From: Nathan McLeod
To: Troy Monroe; Traci Freshour
Cc: Dave DeGrandpre
Subject: Meadowview
Date: Wednesday, April 17, 2024 9:56:37 AM
Attachments: imaoe001.xls

Parks and Recreation Meadowview Homes Sufficiency #3 review

Engineering 3rd Sufficiency Review – Meadow View Homes Subdivision

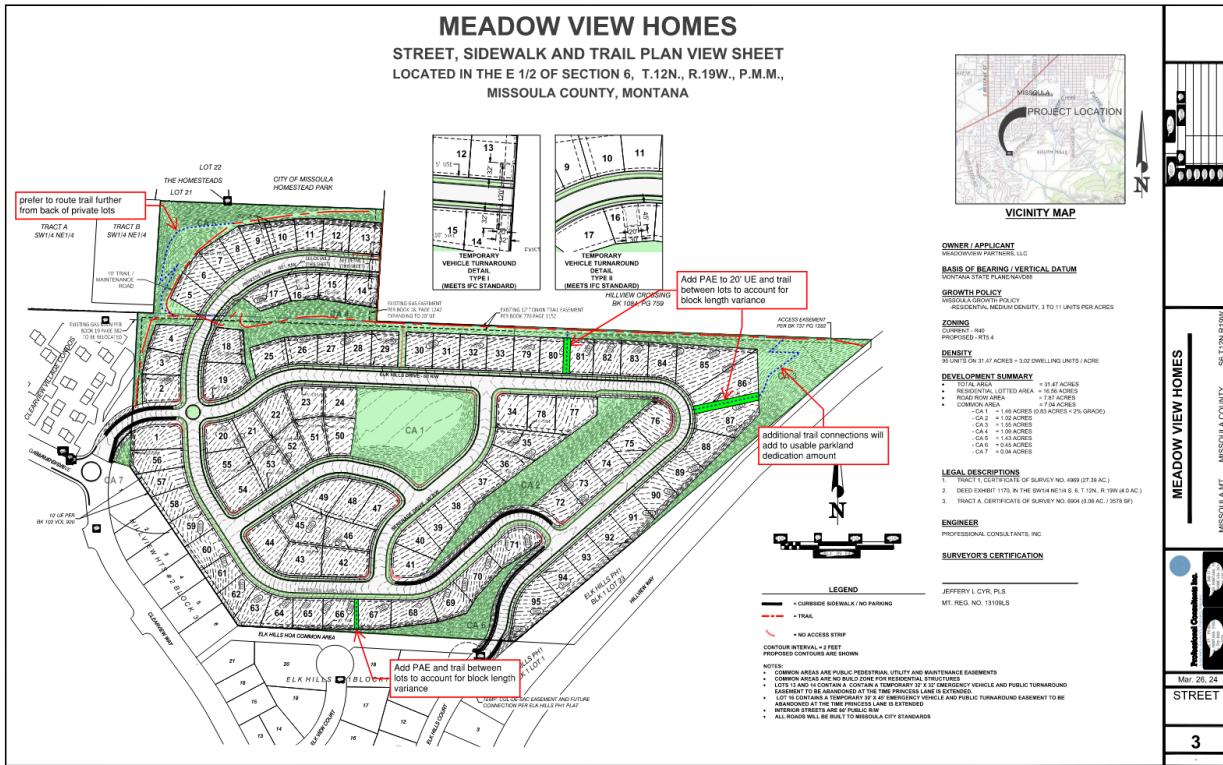
Block Length Variance:

In order to support the block length variance several public access easements with trails should be added as shown in the below preliminary plat markup.

Block Length Variance:

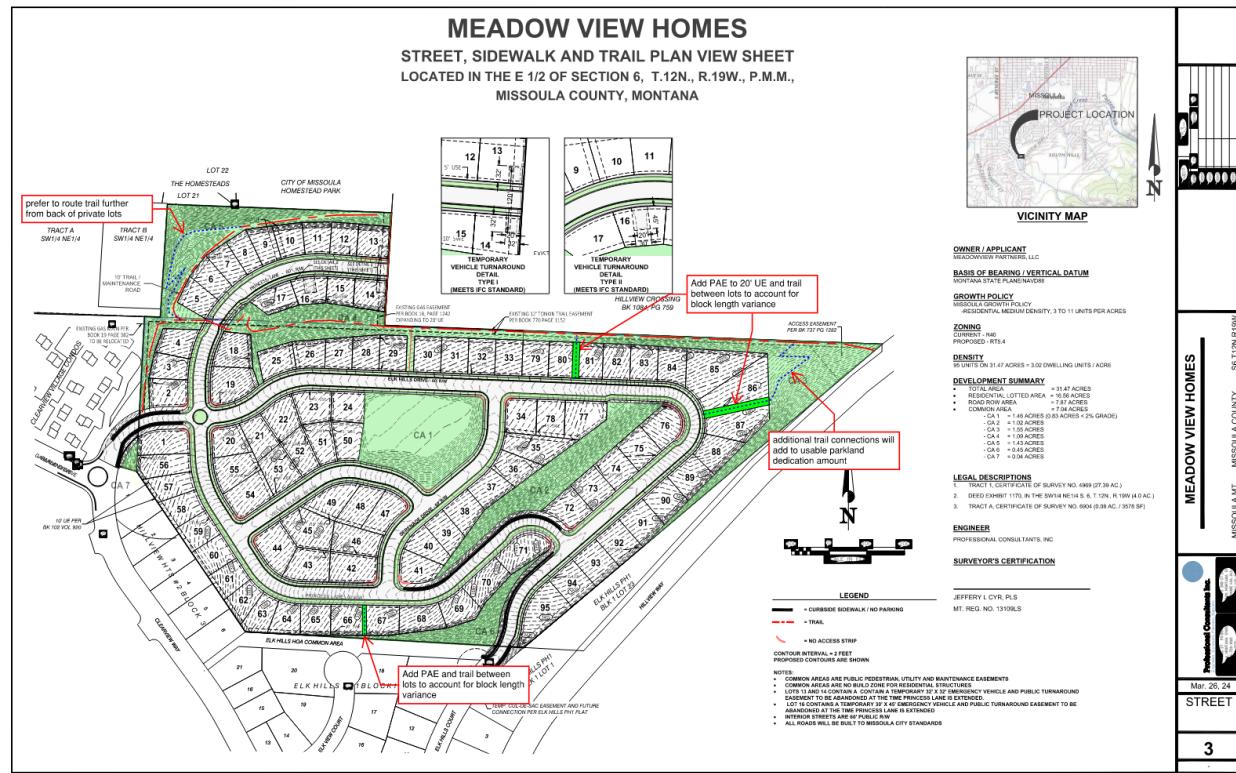
In order to support the block length variance several public access easements with trails should be added as shown in the below preliminary plat markup.

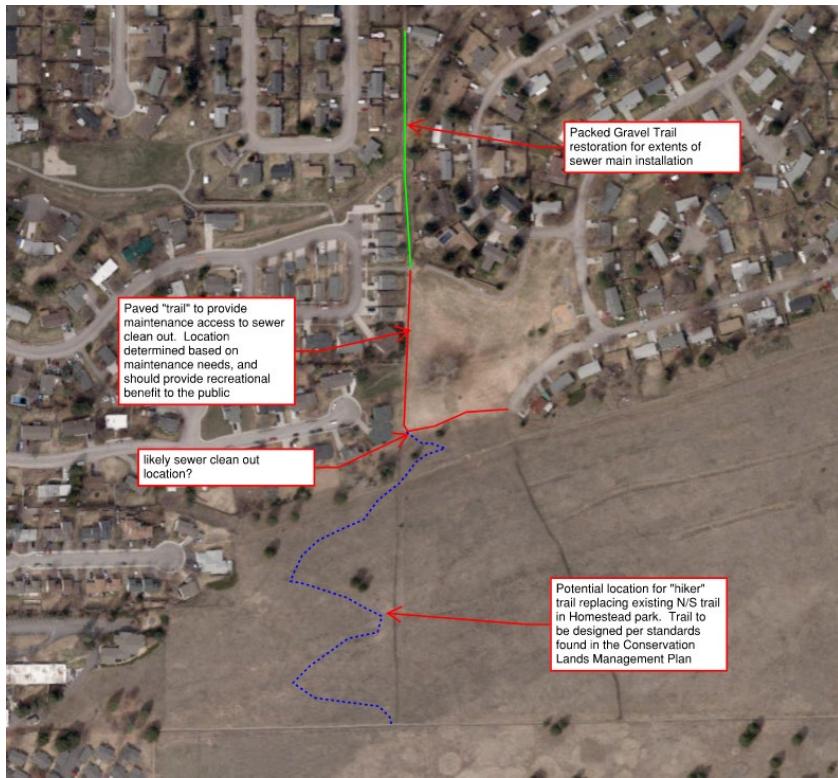
The following note should be added to the boulevard landscaping plan: Street trees will be planted at a linear spacing between 25 and 35 feet, with a minimum of one tree per lot, and while tree locations may change slightly in final design, the total number of trees shown will remain the same.

Include on the plans the utility/site triangle offset table found in the parks design manual.

Parkland Dedication.

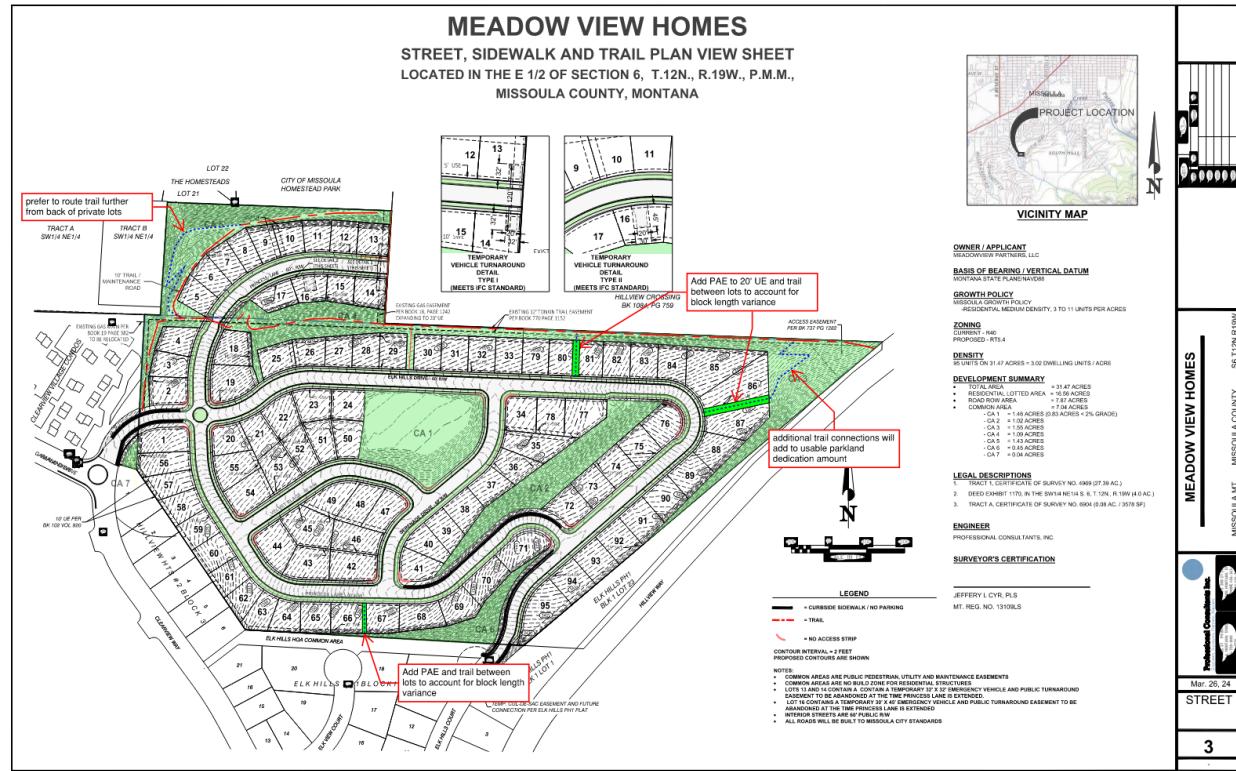
Calculations do not appear to be correct. Certain areas are counted that do not qualify, see image below of highlighted areas that appear to meet the requirements for parkland dedication (note my numbers are not necessarily accurate). There appears to be more than enough common area (parkland) dedicated to meet the requirements however. Note: Areas including stormwater facilities cannot count towards parkland dedication.

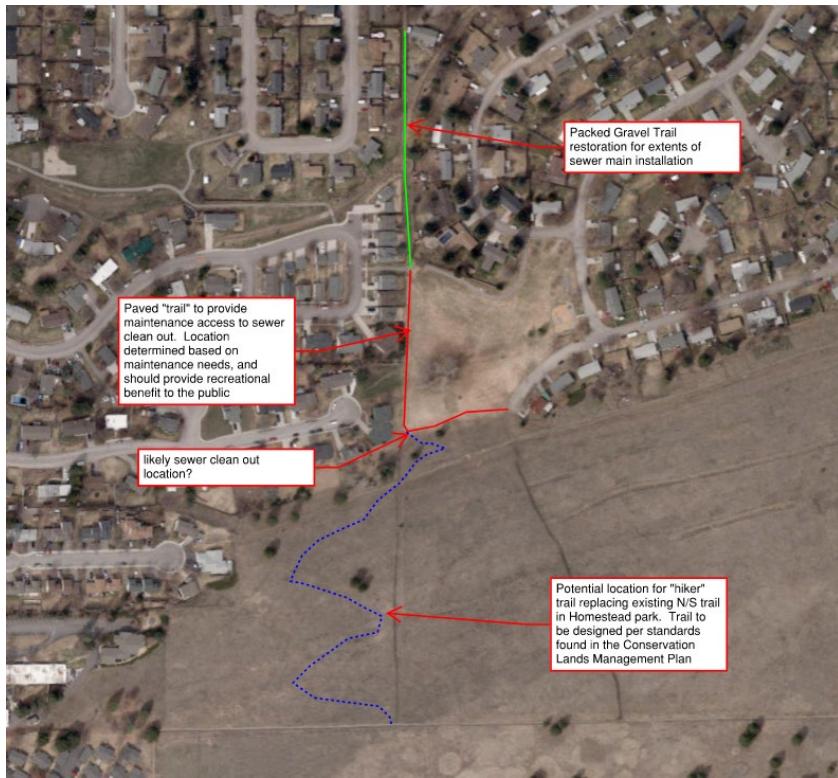
The following note should be added to the boulevard landscaping plan: Street trees will be planted at a linear spacing between 25 and 35 feet, with a minimum of one tree per lot, and while tree locations may change slightly in final design, the total number of trees shown will remain the same.

Include on the plans the utility/site triangle offset table found in the parks design manual.

Block Length Variance:

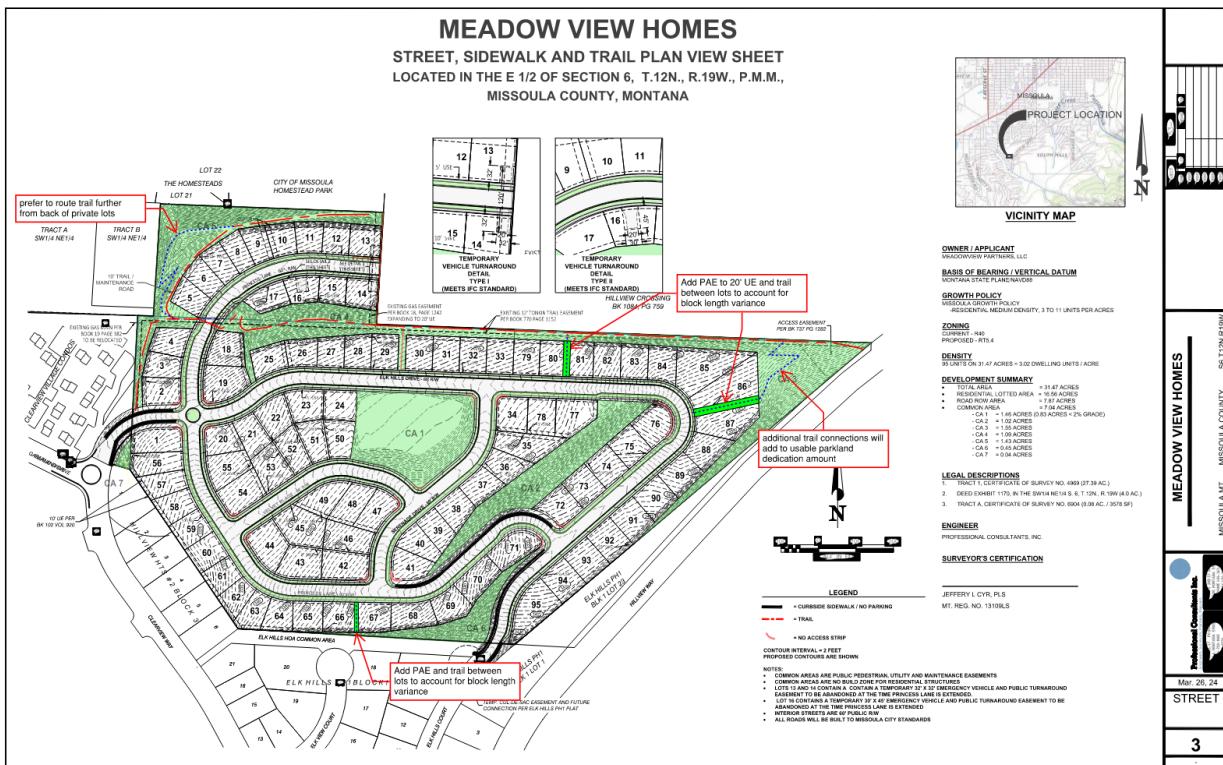
In order to support the block length variance several public access easements with trails should be added as shown in the below preliminary plat markup.

Yes, those additions make sense. The access between 66 and 67 will provide access to CA 6, but the steepness of CA 6 will make it practically useless for anything but sledding. There currently isn't public access to Elk Hills common area, but maybe the Elk Hills HOA won't mind an informal trail to Elk View Court.
